RENEHAN SUBDIVISION

DSD FILE NO.: MS238

RENEHAN SUBDIVISION FINAL PLAT

Project No.: 22027

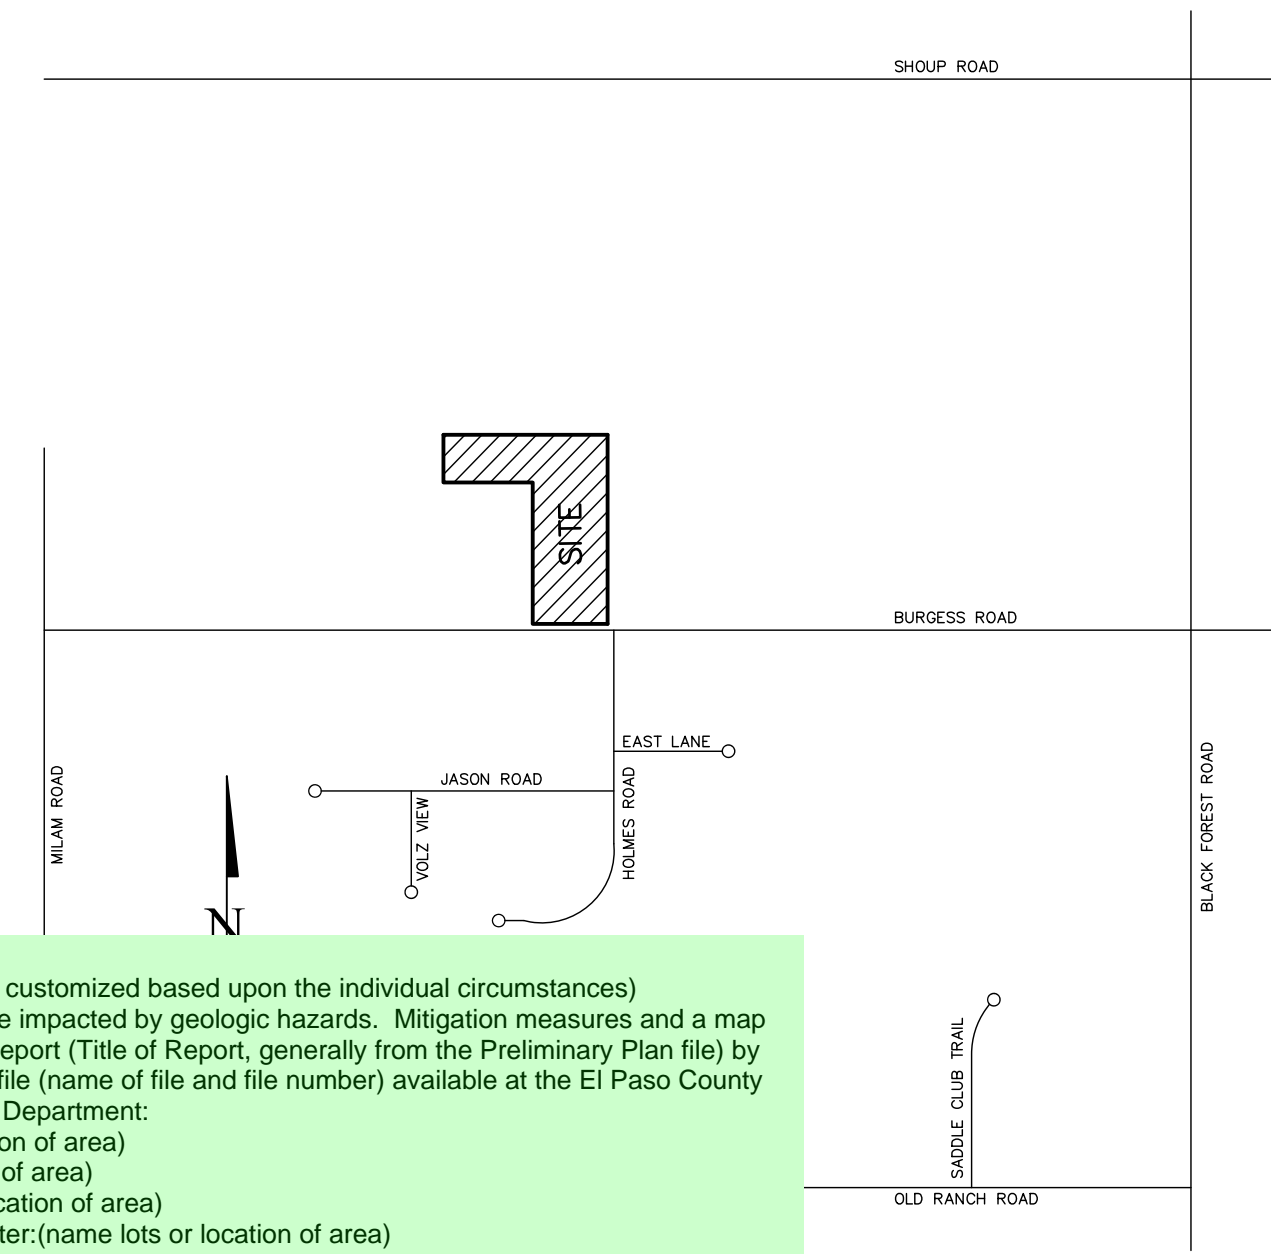
Revise to add the following sentence: "El Paso County is not responsible for the maintenance of driveways."

Engineered septic

Please keep director signature block

RENEHAN SUBDIVISION
FINAL PLAT

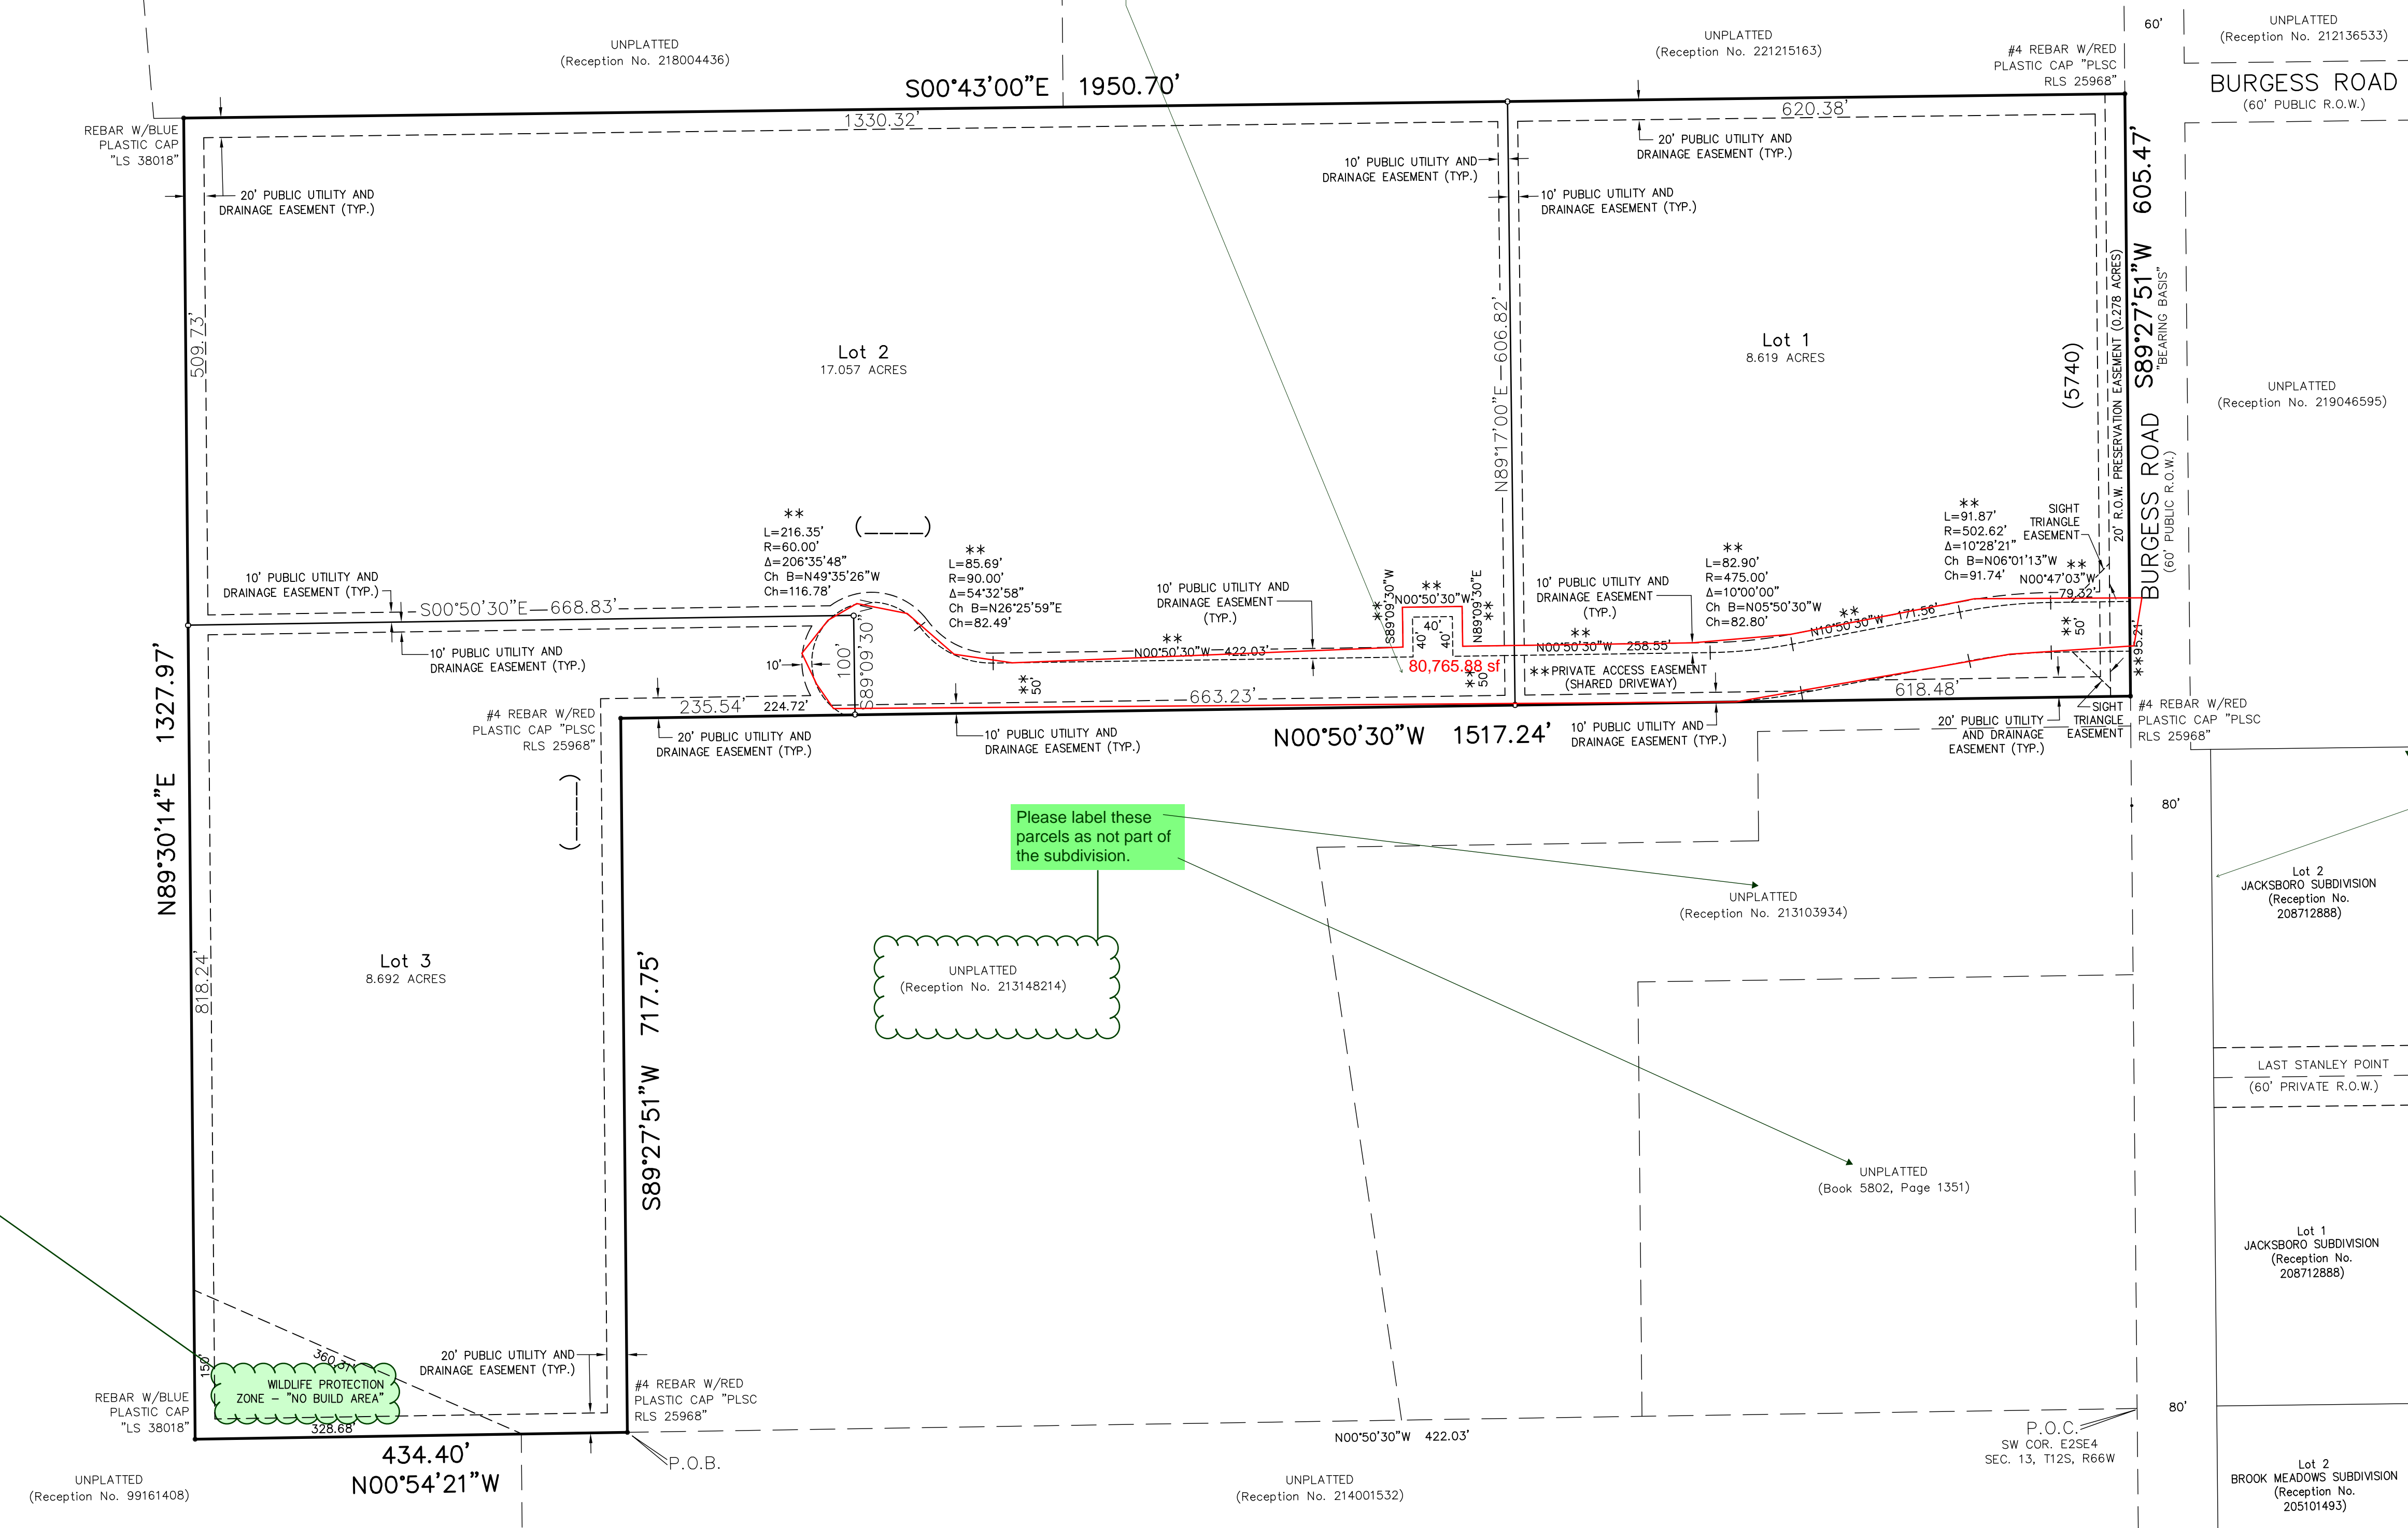
Please provide a name for the road. As a private drive, this should have one of the following suffixes: Grove, Heights, Point, or View.

Please show entire area detailed in geology report.

Please label these parcels as not part of the subdivision.

Please make these lines dotted.
